Engineer Alana Sherman	Size C	Document Number 10020653	Layout File <Layout File>	Rev A
Layout Jose Roal	Date:	Thursday, February 10, 2011	Sheet 1 of 2

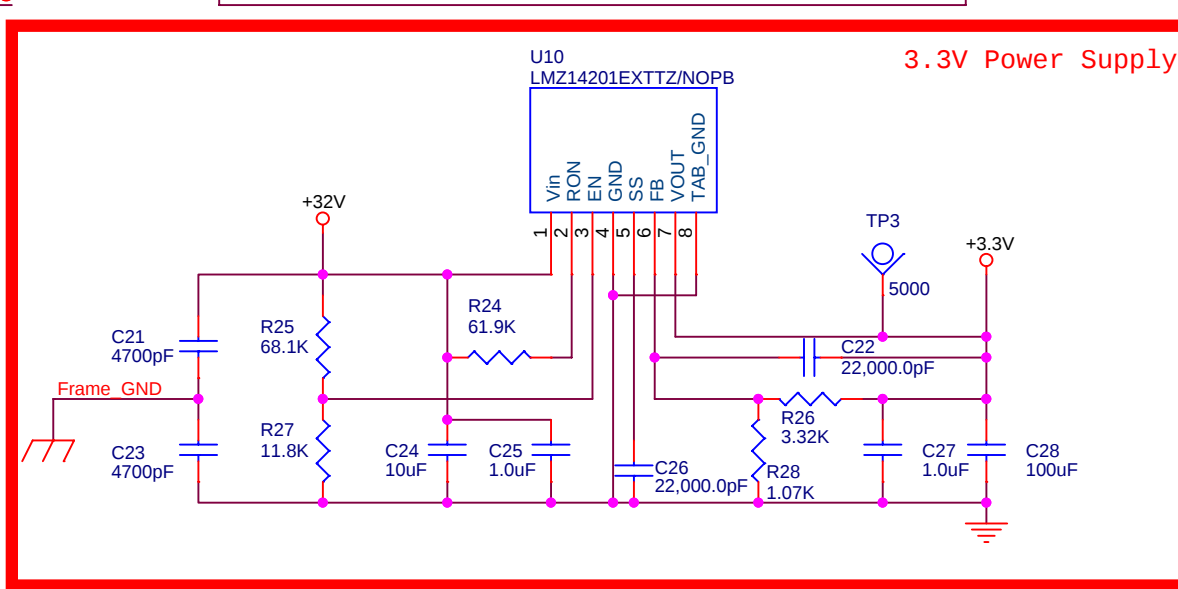
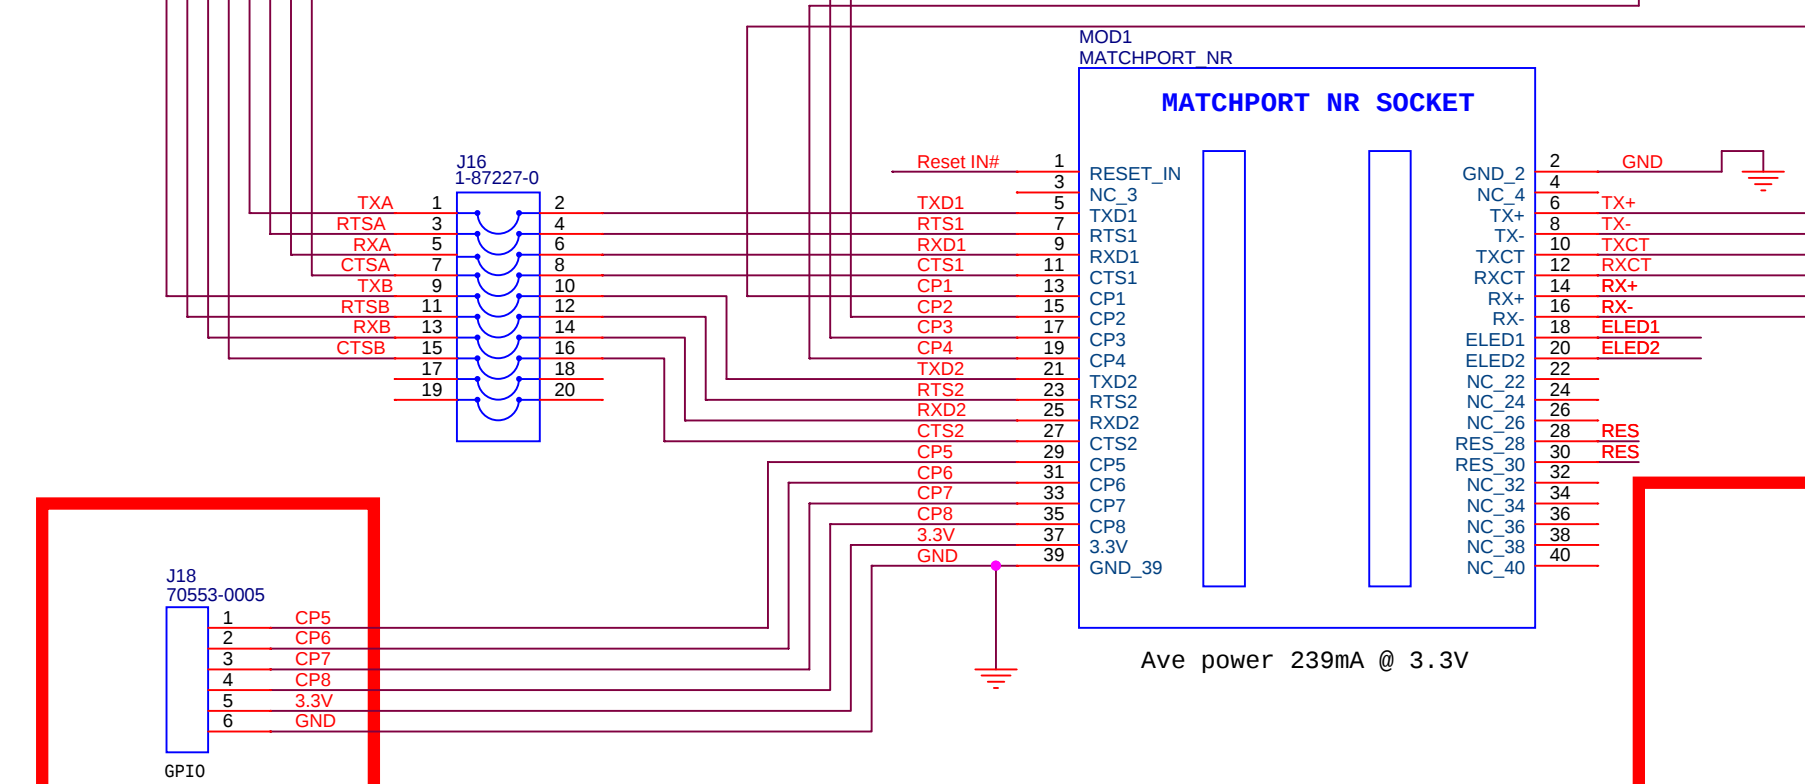
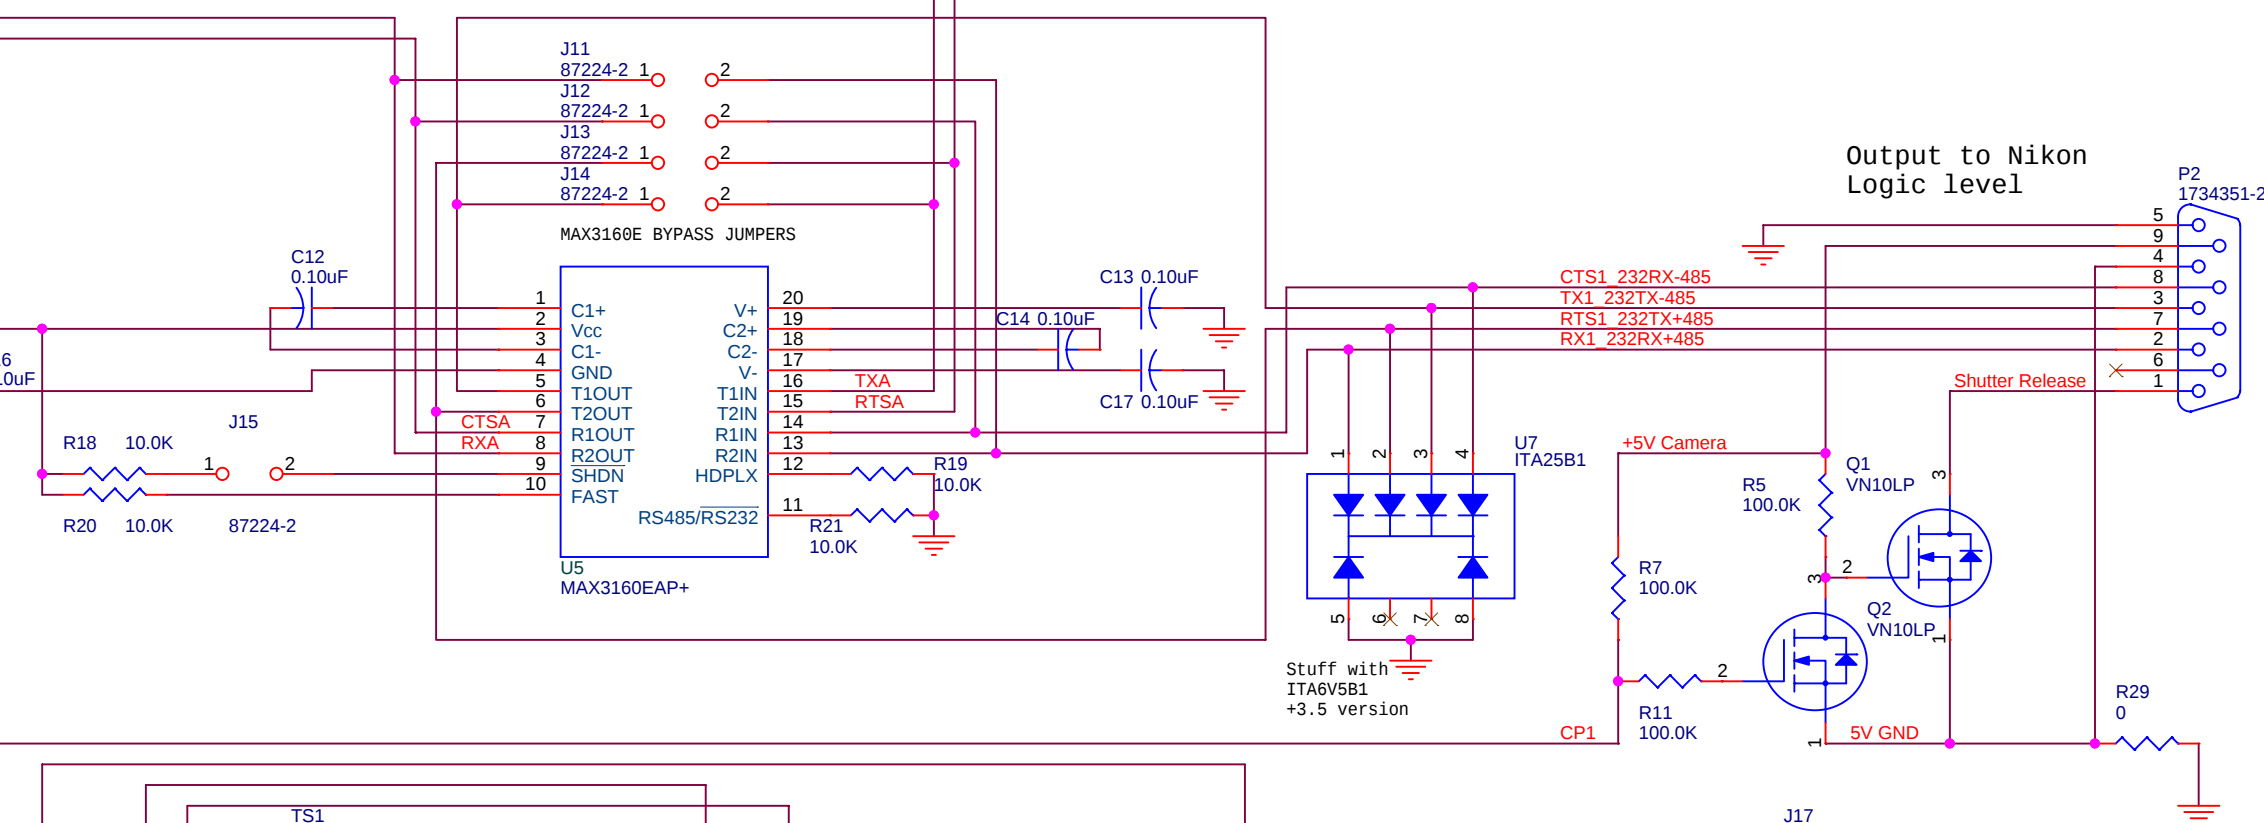
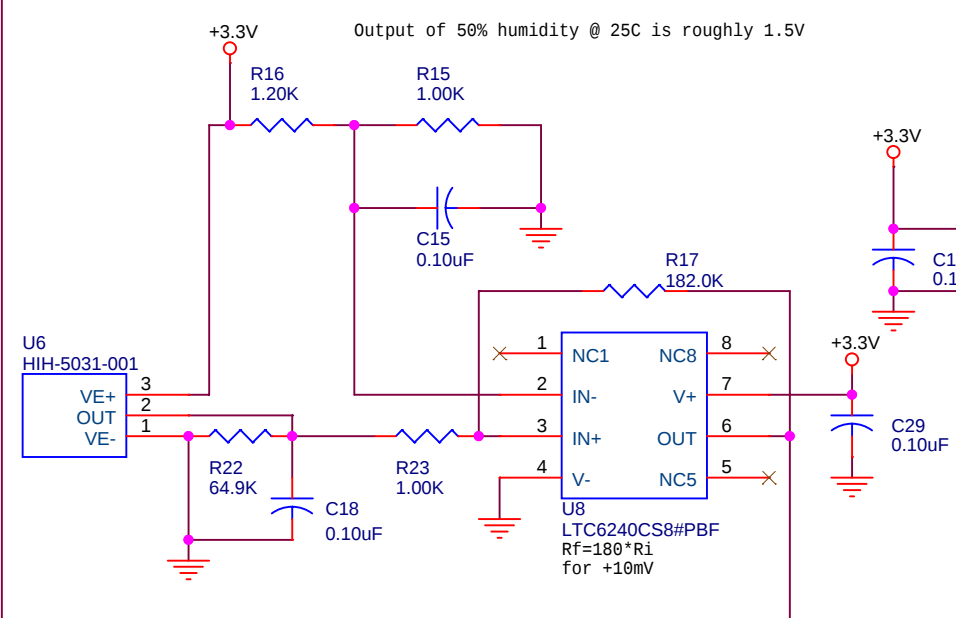
ADDED C5, C6, C30, and L2
Also added third pin to J3 for Frame GND

Changed connector size to 6 pins
